DEVELOPMENT DETERMINATION PANEL MEETING

WEDNESDAY 8 JULY 2020

**MOD2019/0253 - 24 LANCASTER CRESCENT, COLLAROY -
MODIFICATION OF DEVELOPMENT CONSENT DA2016/0963
GRANTED FOR DEMOLITION WORKS AND THE
CONSTRUCTION OF A NEW DWELLING HOUSE AND
SWIMMING POOL**

APPLICATION FOR MODIFICATION ASSESSMENT REPORT

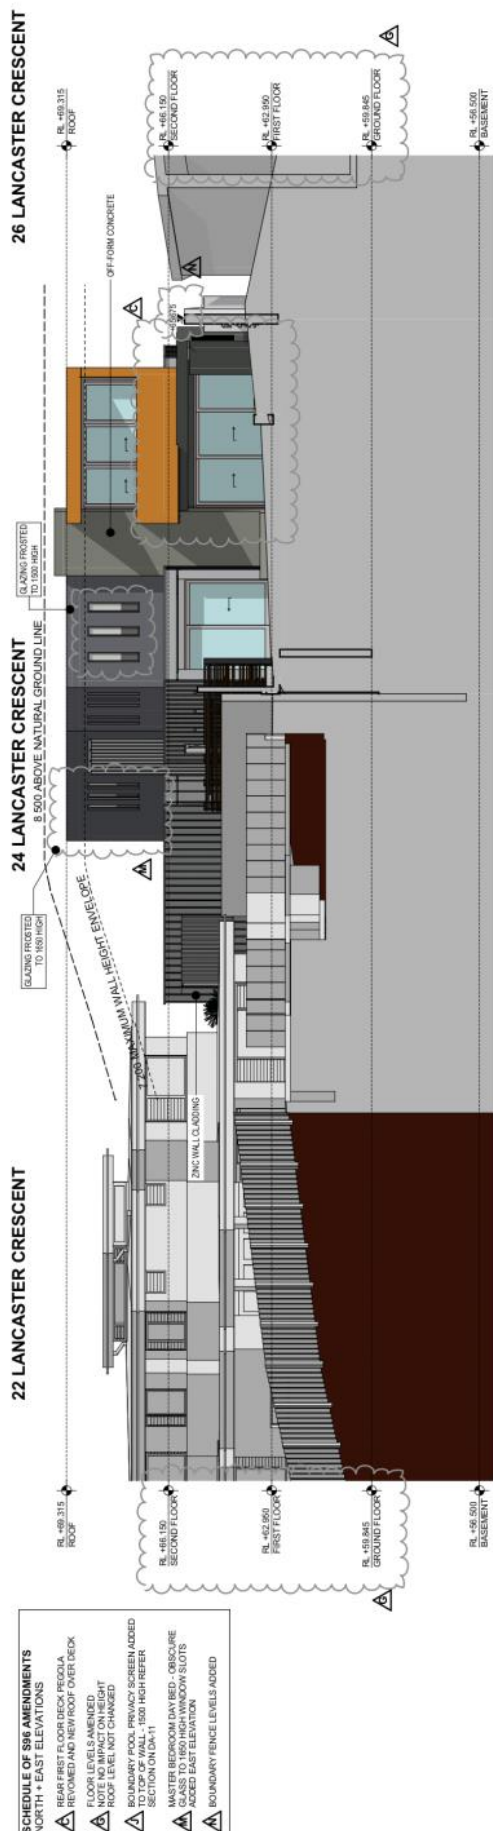
- Plan DA-11 contains an error, as it shows the floor level at 22 Lancaster Crescent as higher than the wall adjacent to the pool at 24 Lancaster Crescent.

The misrepresentation of levels shown by the 'Pool Privacy Screen Section' on DA-11 is noted and is not relied upon for assessment. The Assessing Officer relied upon the relative levels shown on the remaining plans, and observations on site, for assessment.

Photo 6. 3D model indicating approximate views of Store Beach to be regained from first floor front/side terrace.

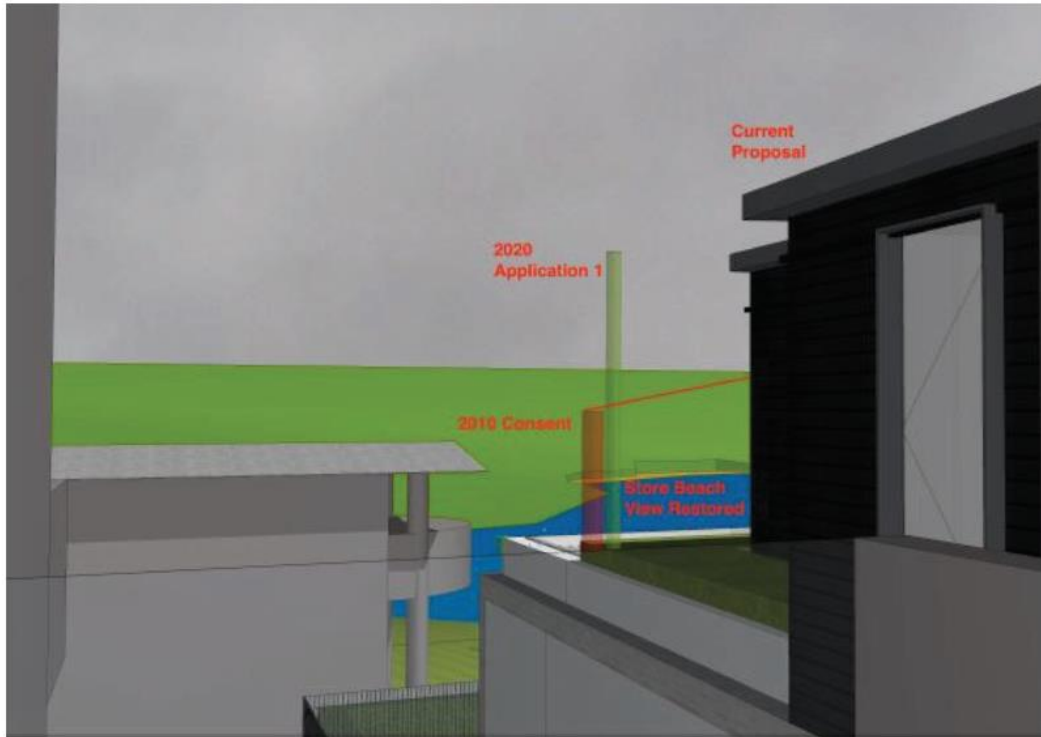
Further views are regained from the first floor front/side terrace (Photo 4). The blue height pole indicating the approved location of the first floor bathroom wall at the rear corner of the dwelling is at RL27.87. Based on the final amendment of the modification, the comparable wall location is now the rear corner of the ground floor pantry (RL26.1), while the first floor bedroom wall (red height pole) has been set back by a further 1.46m from the side boundary. This change results in the ground floor wall being 1.77m lower than the blue pole location, and the first floor wall being 1.46m to the right of the red pole location. It is anticipated that the amendment will regain water and land-water interface views to Store Beach from the first floor front/side terrace that were lost via the previous approval, as indicated by the modelling in Photo 6 below.

The proposed modification will not materially impact the available views of Little Manly Beach across the front of the subject site (Photo 3) or the views of Store Beach from the first floor rear terrace (Photo 5).
